APPROVED MINUTES

File Number: RV3-59/23
Date Received: August 30, 2023
Revised Date: November 15, 2023

Name: Karen Sergeant
Address: 6079 James Bell Drive, Lot 11, Concession A,
Manotick, City of Ottawa

Exhibit 9 - Initial Cross Section Submission – Submitted August 30, 2023

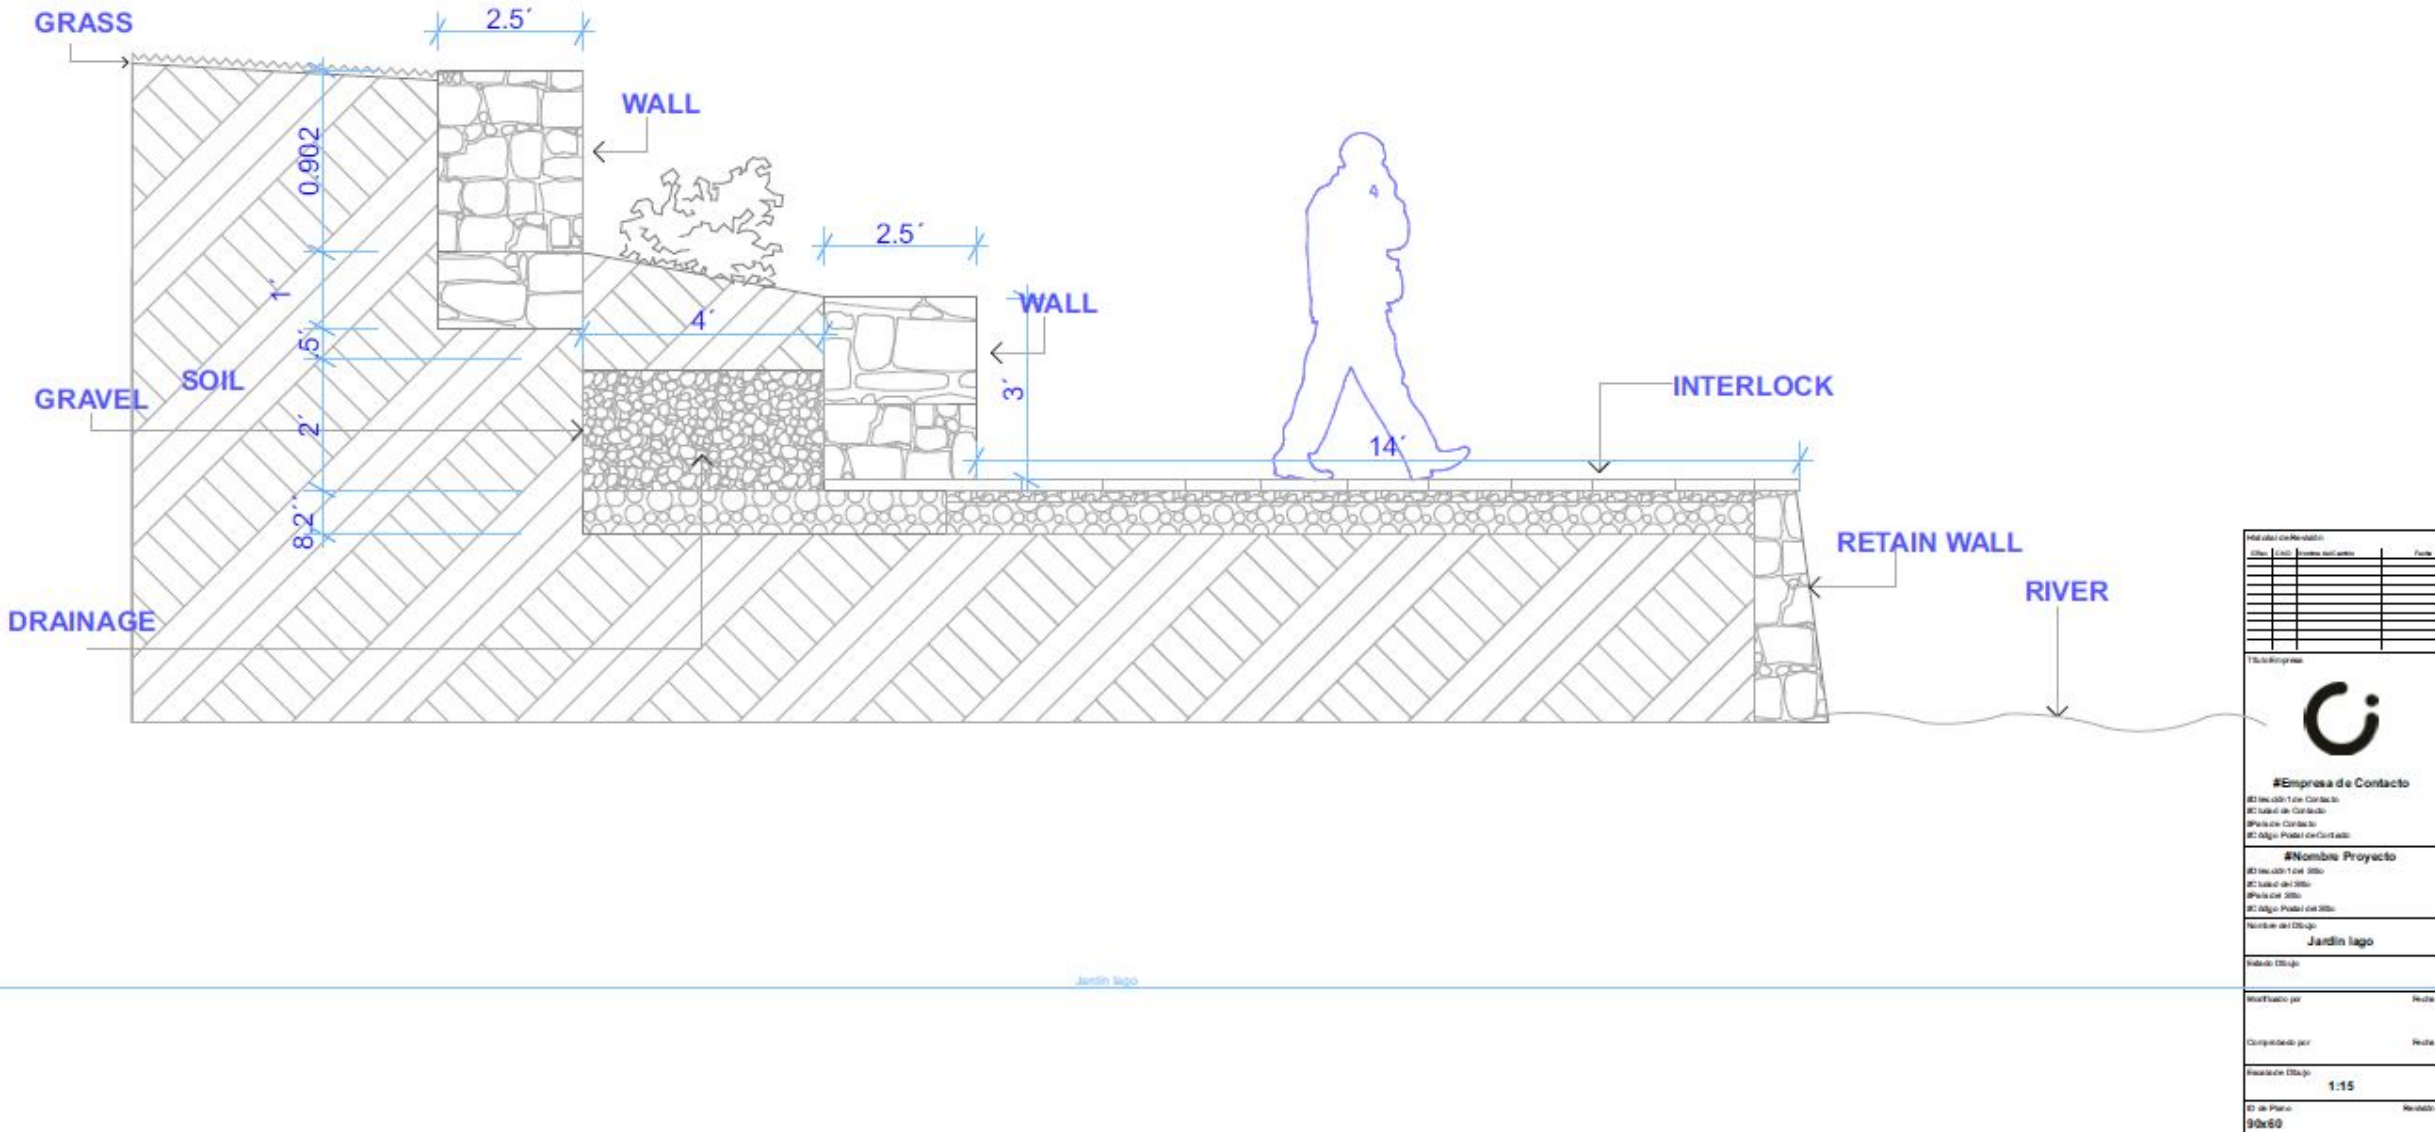
Exhibit 8 presents the initial site plan submitted by the applicant on August 30, 2023, in response to the initial site conditions outlined in Exhibit 7. Mr. Davidson elaborated; staff conducted a review of the drawing and identified inconsistencies in dimensions, along with a lack of geodetic elevations.

Exhibit 19 – Submitted Retroactive Revised Site Plan

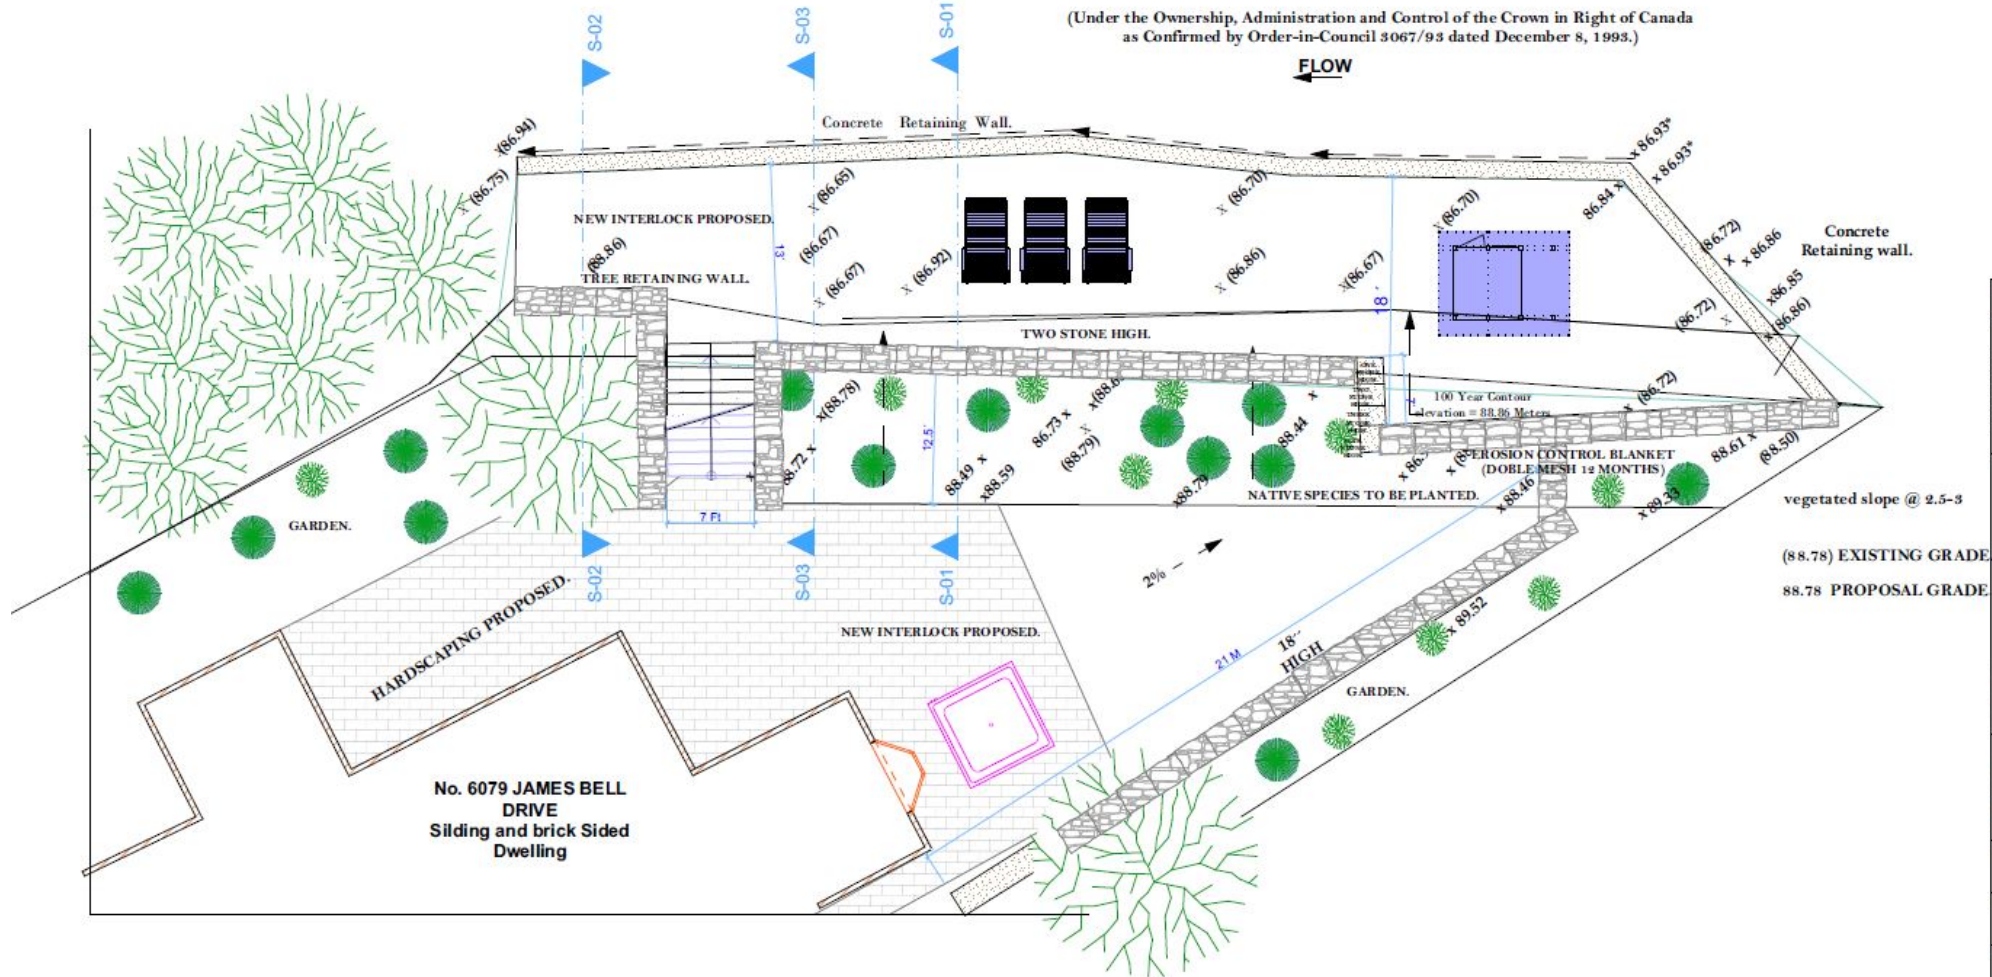
Mr. Davidson elaborated on the revised proposal, as outlined in the site plan submitted on November 15, 2023. The plan includes a vertical armour stone wall approximately twenty-three (23) meters long, ranging from twenty-nine to forty eight (29 to 48) inches in height, positioned about thirteen to eighteen (13 to 18) feet from the shoreline. Another eighteen (18) inch, sixty-two (62) feet long armour stone wall is proposed along the southern edge of the property. Additional interlock hardscaping extends past the eastern edge of the dwelling, reaching up to the crest of the slope in some areas.

Exhibit 20 – Submitted Retroactive Revised Cross-Sections

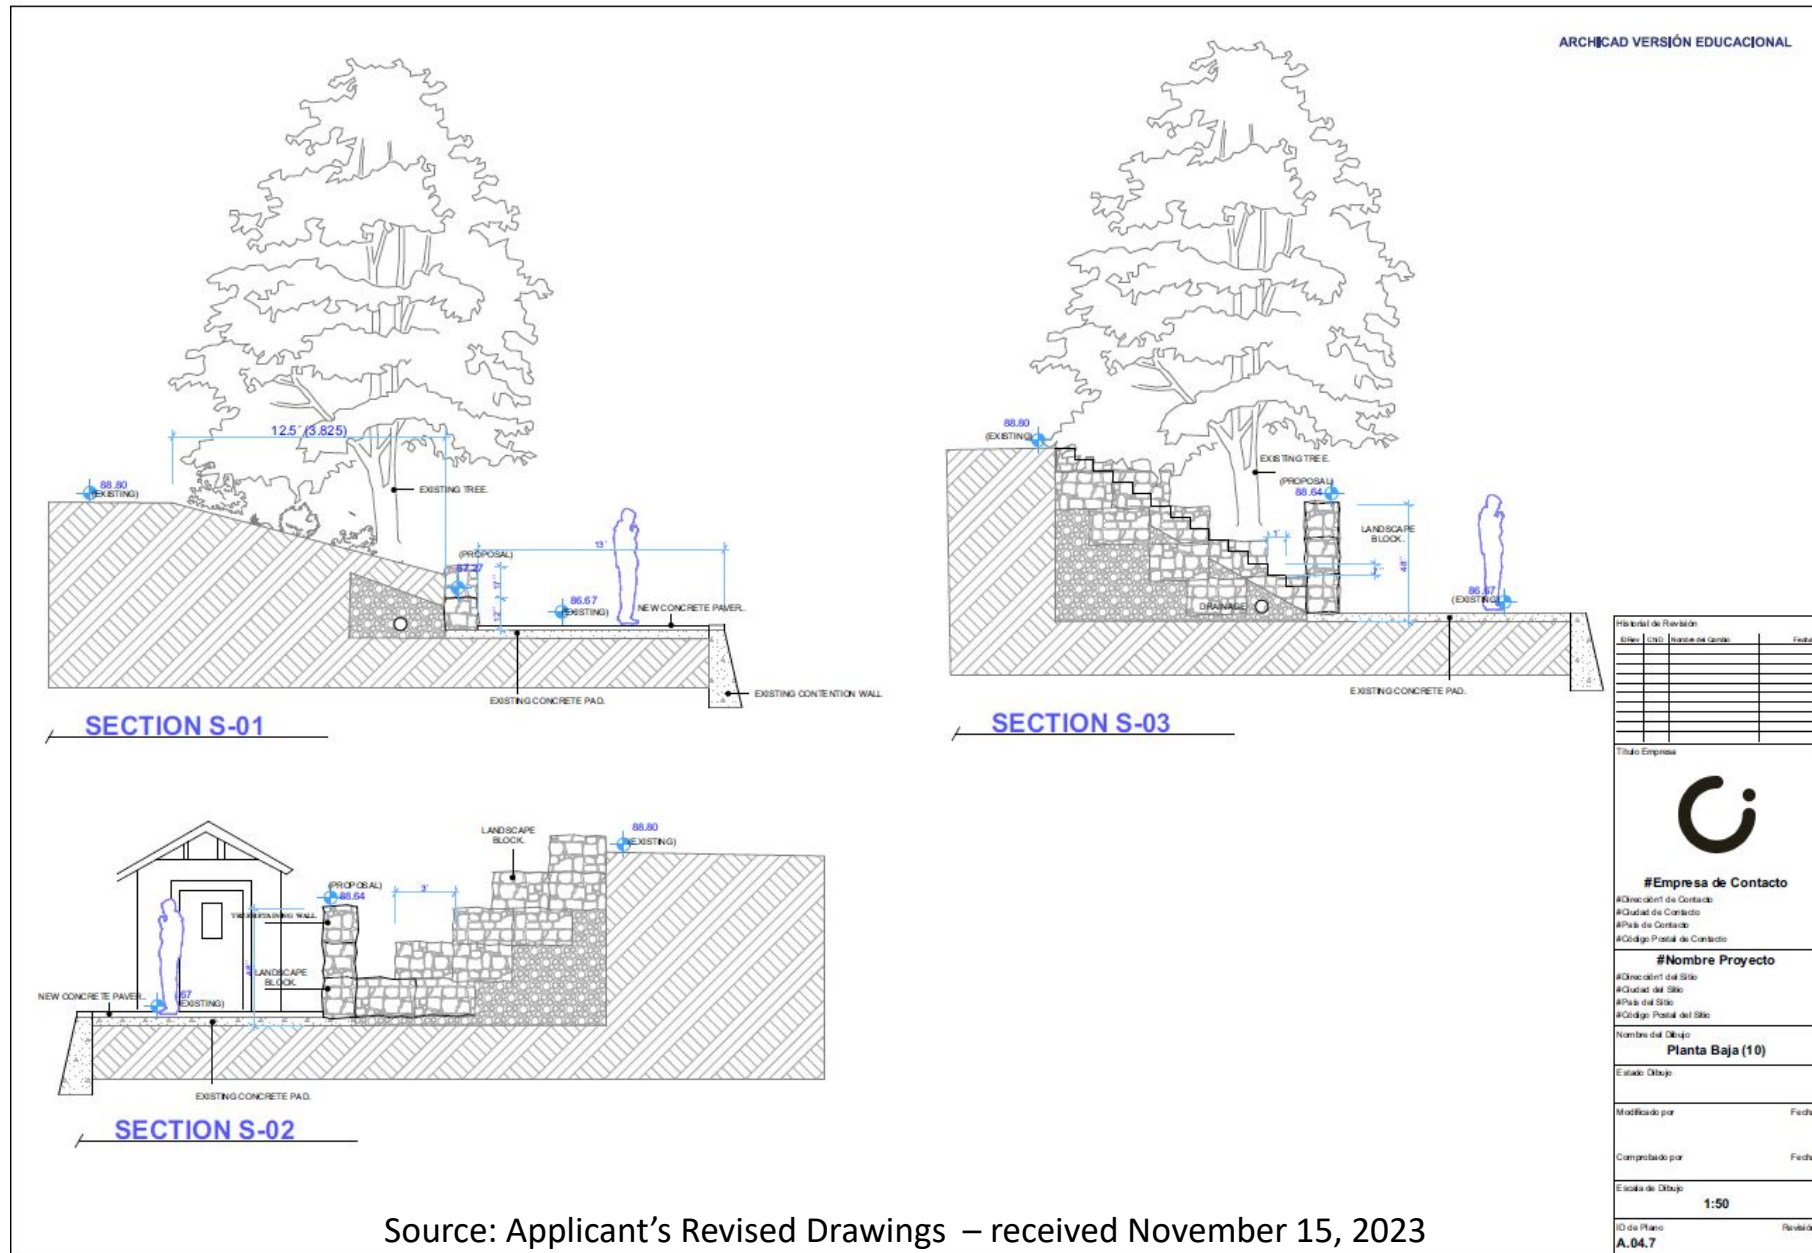
Mr. Davidson elaborated on the details of the retroactive revised site plan, elucidating that the submission includes a cross-section diagram outlining the placement of the armour stone on the existing concrete pad. The diagram illustrates plans to taper the armour stone wall to a height of four to five stones. Furthermore, the drawing specifies the addition of a new concrete paver on the existing concrete pad, featuring approximately four to six inches of gravel covered by interlock paver stones atop the concrete pad.

The submission also includes a cross-section diagram. The cross-section drawing indicates the proposal to place the armour stone on the existing concrete pad. And to taper the armour stone wall up to 4 stones high.

Exhibit 23 - Issues with Revised Proposal 1/3

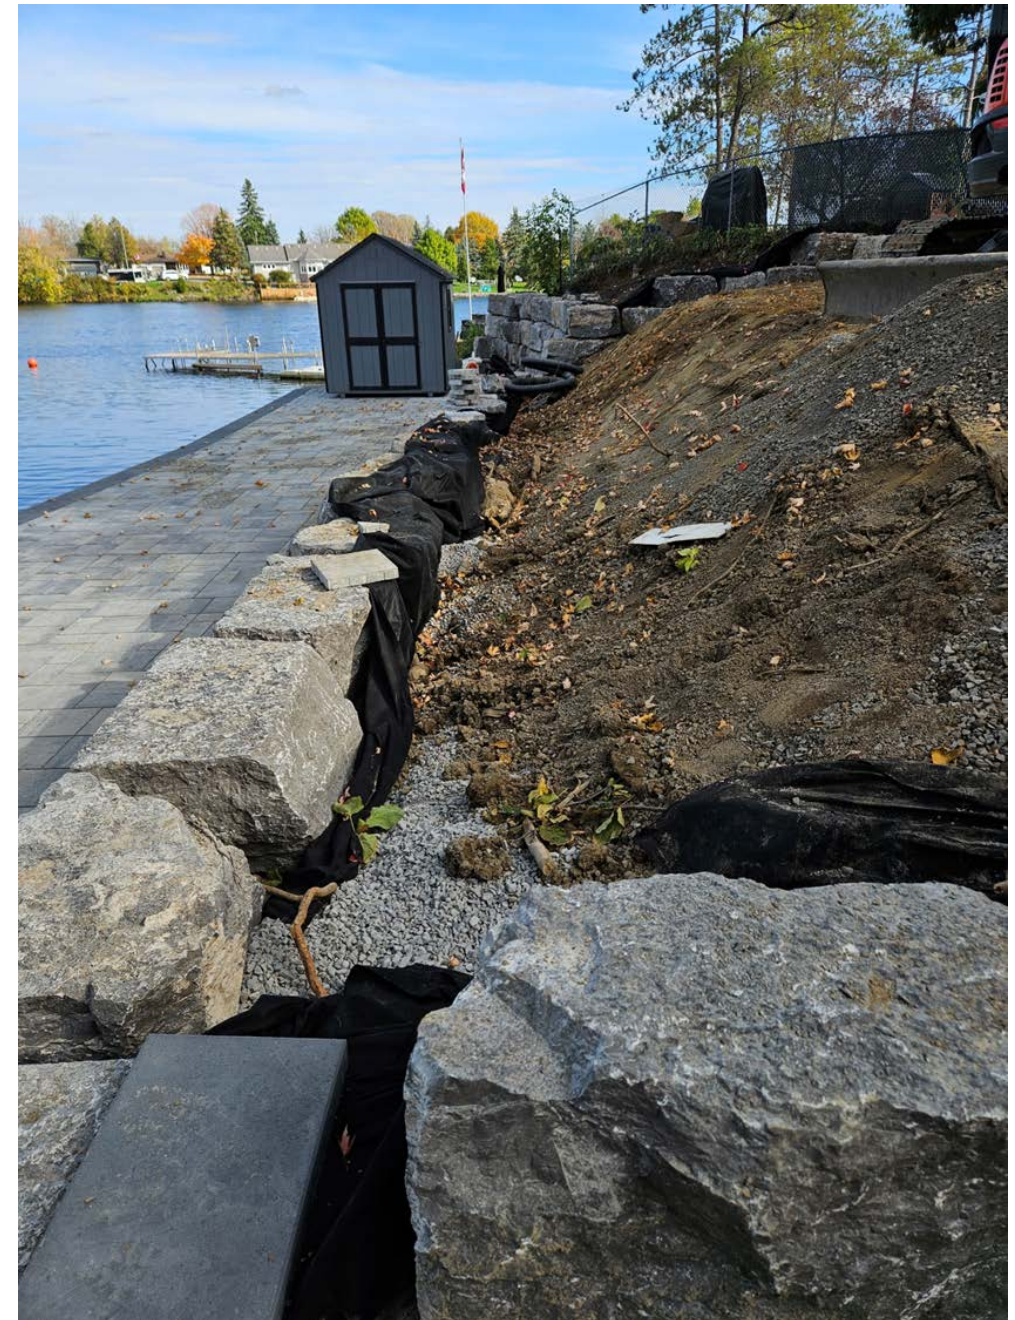
Mr. Davidson added that toe erosion from the watercourse is an improbable cause for the site's previous conditions, given that the lower concrete structure provides the primary erosion protection. He emphasized that the minor erosion observed on the slope is more likely attributed to the natural degradation of the wooden retaining walls and runoff from precipitation. In response to these sources of erosion, sustainable erosion mitigation techniques, rather than an armour stone retaining wall and hardscaping, could be effectively employed.

Mr. Davidson emphasized that the larger armour stone crib and the armour stone abutting the access stairs are instances of unnecessary additional hardscaping from an erosion control and slope stability perspective. He highlighted that such additions increase the potential for sheet runoff on the site.

Furthermore, he pointed out that the installation of four-to-six-inch (4 to 6) gravel and interlock on the concrete pad resulted in approximately seven point four (7.4) cubic meters of fill being added within the 1:100-year floodplain. While this volume may not individually pose a significant impact on floodplain storage, Mr. Davidson stressed the precedent set by this development for shoreline
